PCN # ESW490-46 – Alternate Assembly Location for IXYS Power Thyristor & Diode TO-220AB_AC Package

Product/Process Change Notice (PCN)

PCN Report

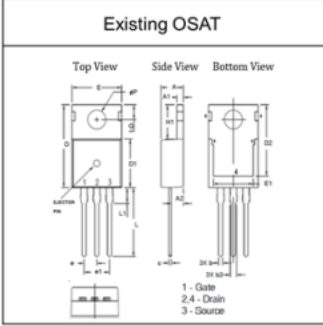
TO-220AC POD SPEC gap in A, C&E. But the actual measurement data all within Littelfuse SPEC.

Items	Existing OSAT		Items	New OSAT		New OSAT Actual Data		
	Min	Max		Min	Max	Min	Ave.	Max
A	4.32	4.82	P	4.19 _±	4.70 _±	4.40	4.46	4.51
A1	1.14	1.39	Q	1.22	1.37	1.26	1.28	1.30
A2	2.29	2.79	V	2.38	2.80	2.56	2.58	2.61
b	0.64	1.01	L1	0.63	0.92	0.83	0.84	0.85
b2	1.15	1.65	M1	1.14	1.40	1.28	1.30	1.31
C	0.35	0.56	W	0.35	0.64 _±	0.46	0.48	0.50
D	14.73	16.00	E	14.98	15.62	15.25	15.30	15.36
E	9.91	10.66	A	9.67 _±	10.42 _±	10.17	10.21	10.26
e	5.08BSC		N	4.95	5.21	5.06	5.08	5.11
H1	5.85	6.85	B	5.96	6.48	6.21	6.23	6.25
L	12.70	13.97	H	12.71	13.97	13.30	13.37	13.42
L1	2.79	5.84	Z	3.30	3.81	3.39	3.48	3.70
ΦP	3.54	4.08	ΦF	3.63	3.89	3.78	3.83	3.87
Q	2.54	3.18	C	2.54	3.05	2.68	2.73	2.77

Conclusion: The variance is not critical which has no significant impact on customer application.

Tube dimension:

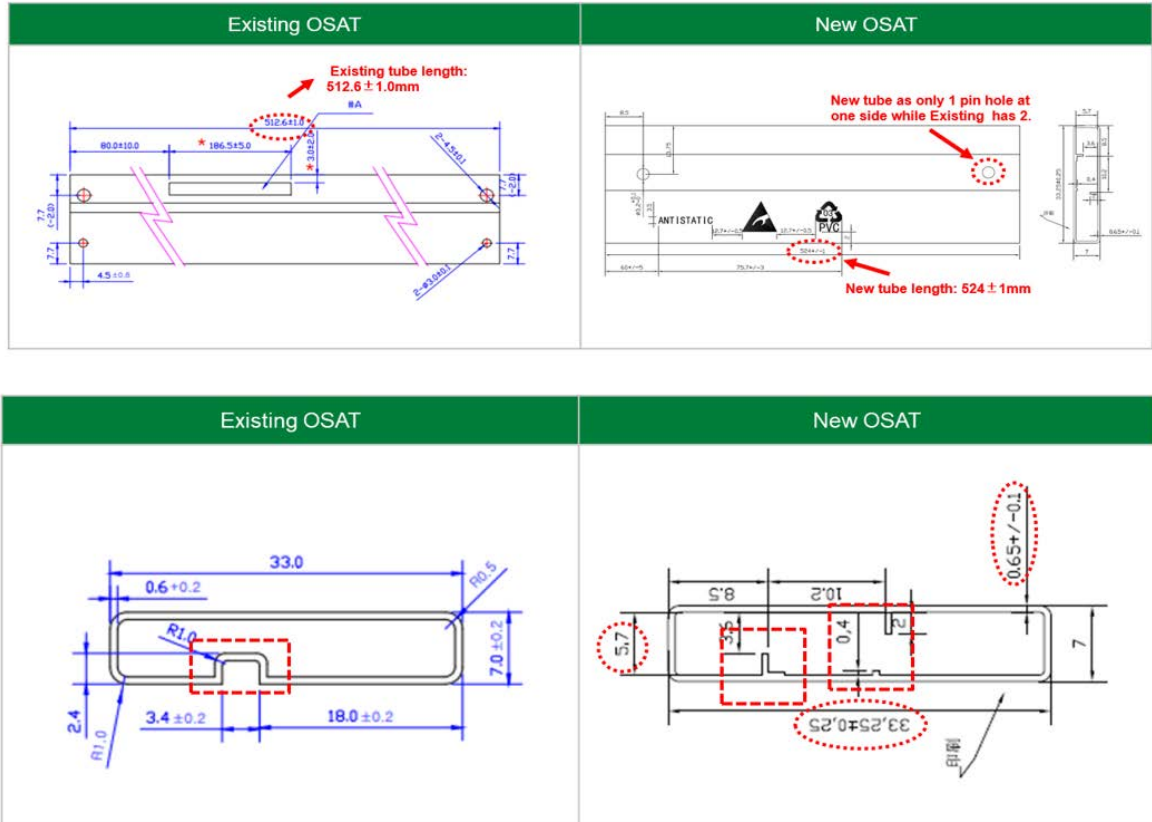
Item	Description	Existing OSAT	New OSAT
1	Size of Inner Box	568*155*55mm	565*105*43mm
2	Size of Outer box	586*230*167mm	585*235*119mm
3	Size of Tube	512.6*33mm	534.5*33mm
4	Packing Qty per Tube	50 pcs	50 pcs
5	Packing Qty per Inner Box	1000 pcs	500 pcs
6	Packing Qty per Outer Box	8000 pcs	2500 pcs

- Inner/Outer Box dimension & packing qty: Alternative Assy site's packing box is smaller than existing Assy site which lead to less packing qty. But it does not affect the MOQ.
- Tube dimension: Alternative Assy site's packing tube for TO-220 is different from existing Assy site. The difference may or may not impact the device unloading at customer side.
